**LAKE MANITOBA AND LAKE
ST. MARTIN OUTLET CHANNELS
PROJECT
Environmental Impact Statement
May 2023 Project Description
Update**

**PROJECT DESCRIPTION
UPDATE**

**LAKE MANITOBA AND LAKE ST. MARTIN OUTLET CHANNELS PROJECT
ENVIRONMENTAL IMPACT STATEMENT
MAY 2023 PROJECT DESCRIPTION UPDATE**

Figure 3C-7b LMO Cross-Section Details

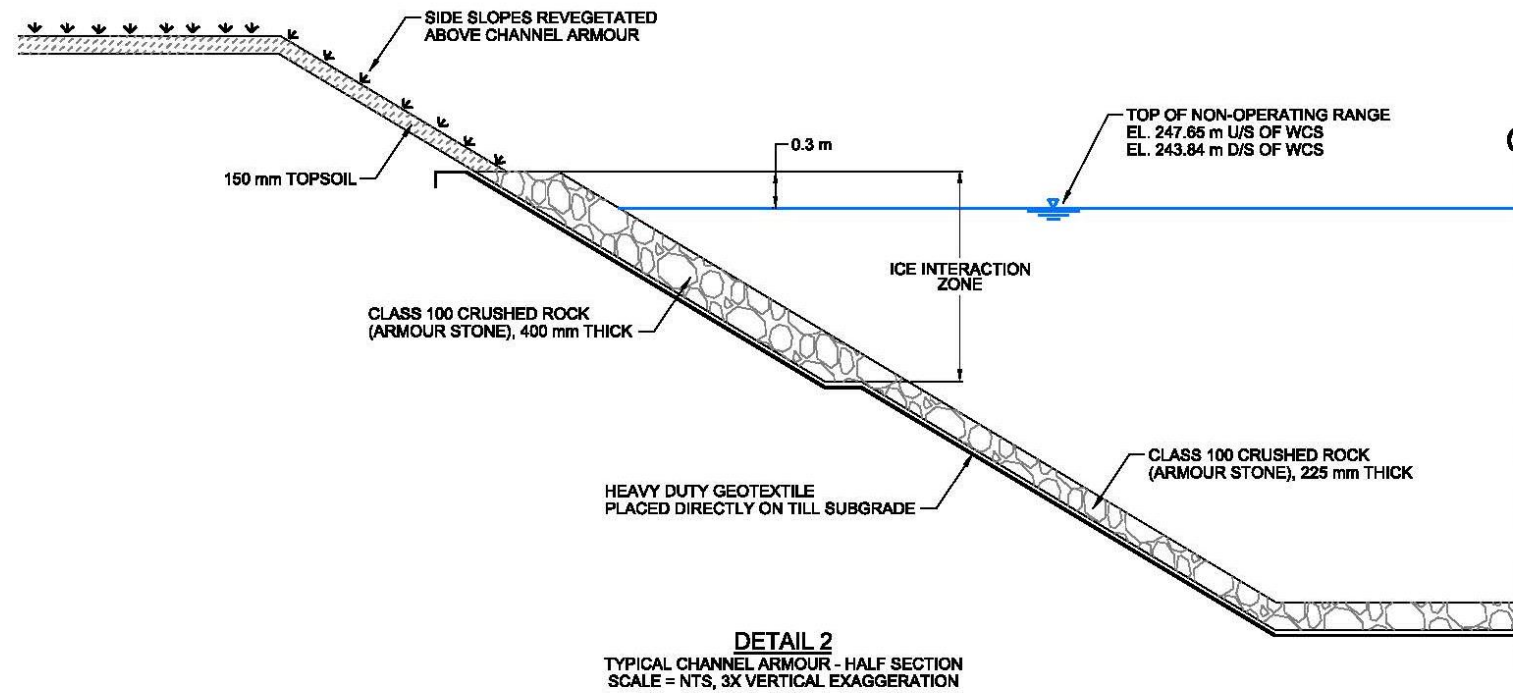
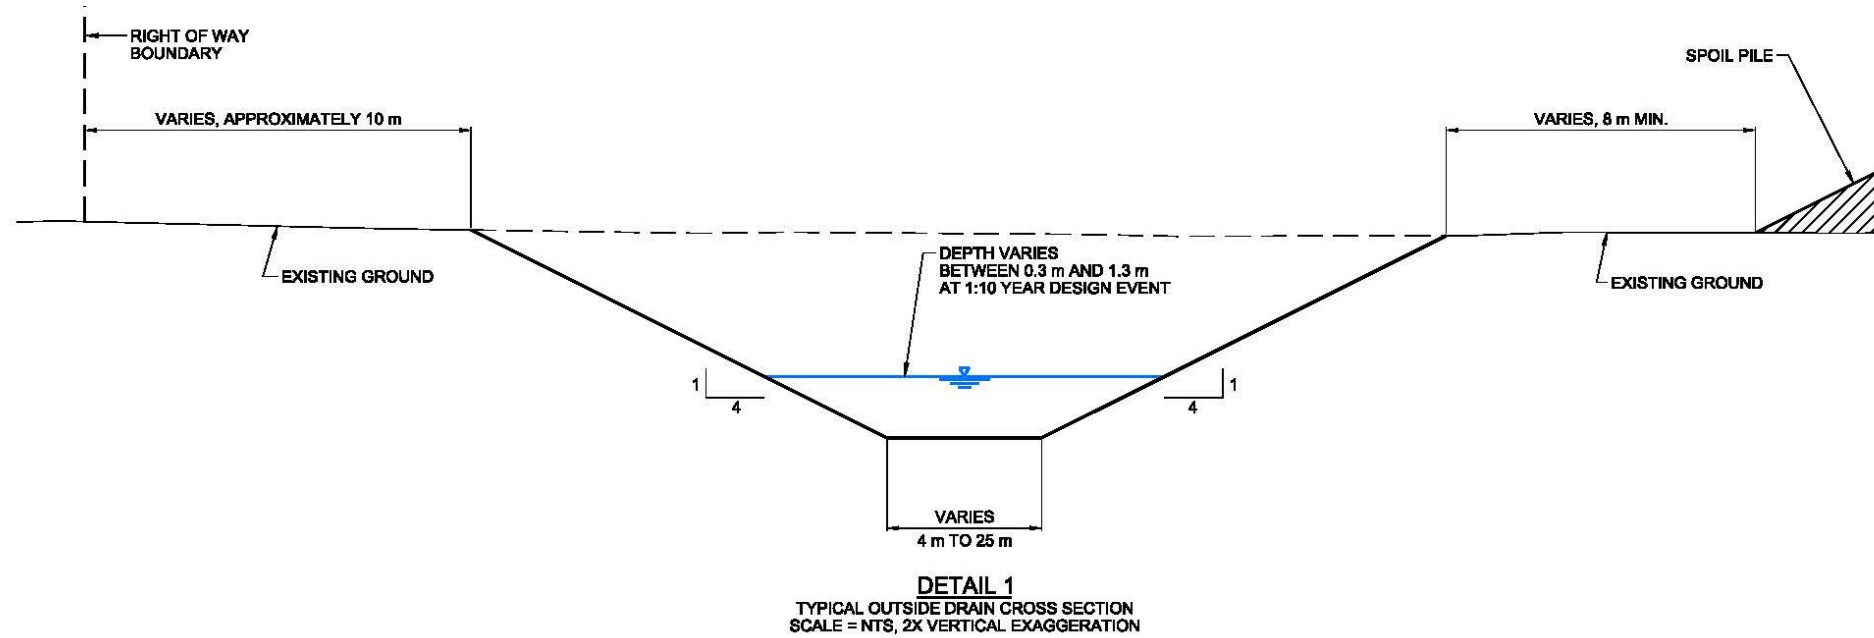
The hydraulic design of the outside drain is based on a trapezoidal channel shape with 4H:1V side slopes and sized for a 1 in 10-year runoff event. Typical cross-sections are shown in Appendix C, Figure 3C-7b. The drain base width varies between 4 m (13.1 ft) and 25 m (82.0 ft). Average velocities within the outside drain will generally be less than 1 m/s (3.3 ft/s) during the design runoff event, which will be accommodated by the vegetation that will have grown in the drain. Erosion protection measures (riprap, and not channel armouring) will be used in specific areas where hydraulic conditions exceed 1 m/s. This includes culverts at road crossings, the steeper portions of the north outside drain reach near Iverson Road and where the north outside drain connects to Lake St. Martin. A small riprap apron will also be installed on the lakebed where the drain outlets into the lake.

Figure 3C-9 LMO Inlet Plan

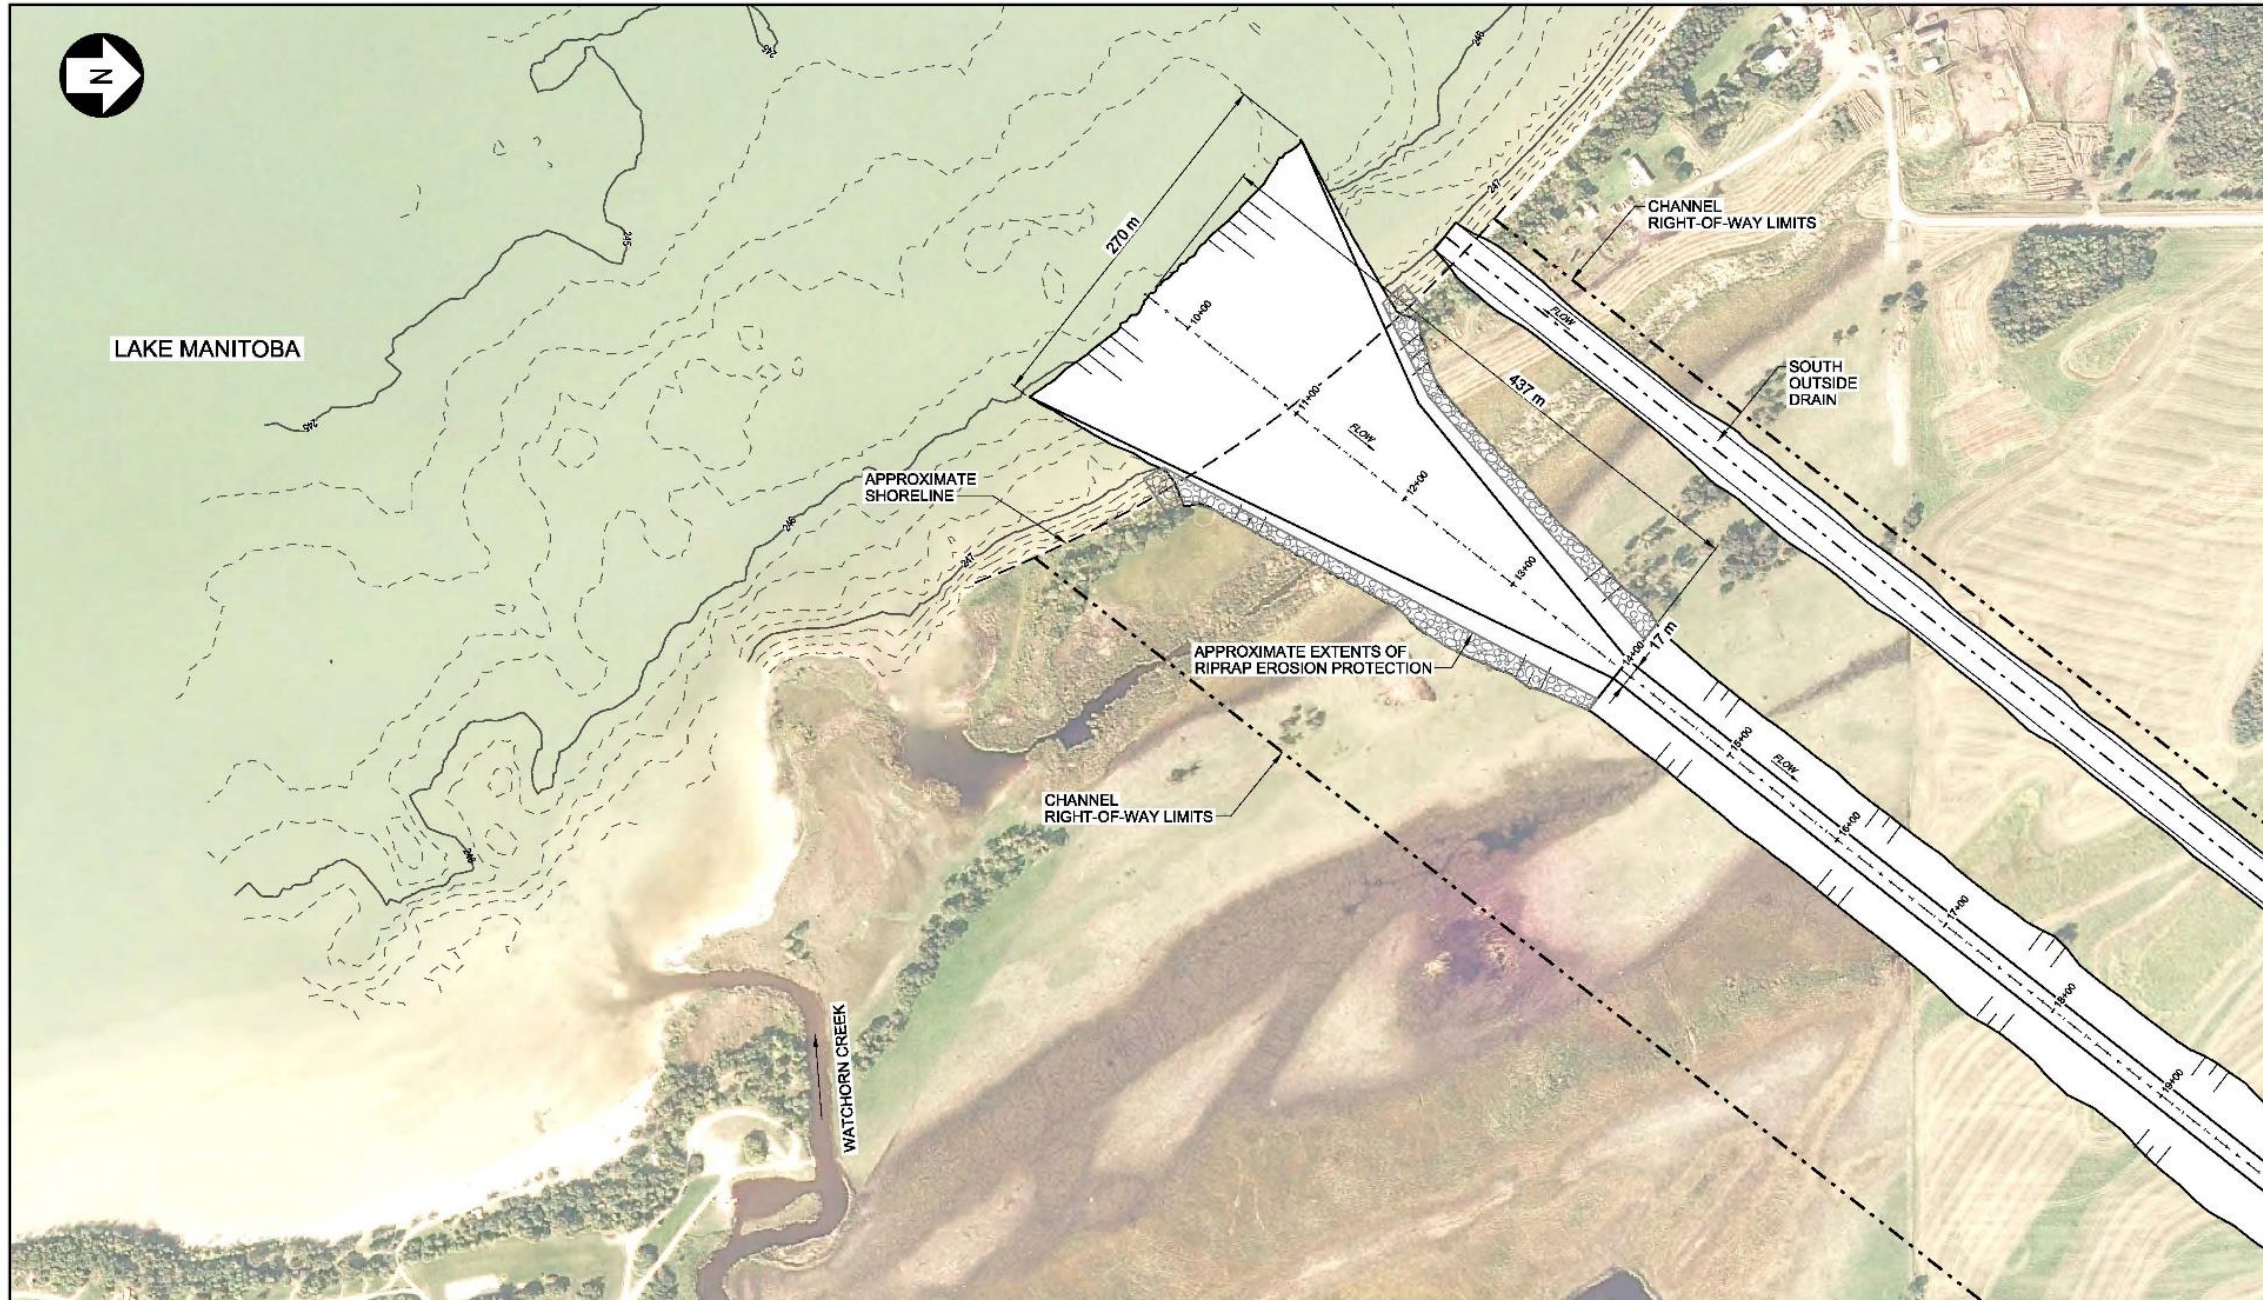
The hydraulic profile of the channel will require the lake bottom to be excavated at the channel inlet and outlet to match proposed channel invert elevations (Appendix 3C, Figure 3C-9 and 3C-10, respectively). Additional design details on the channel inlet and outlet have been developed since the March 2020 Project EIS.

There was no detail available on inlet geometry in the March 2020 Project EIS. It noted that the excavations will be tapered over a distance of 500 m or less from shoreline to meet existing lakebed elevations. More recent information is provided below.
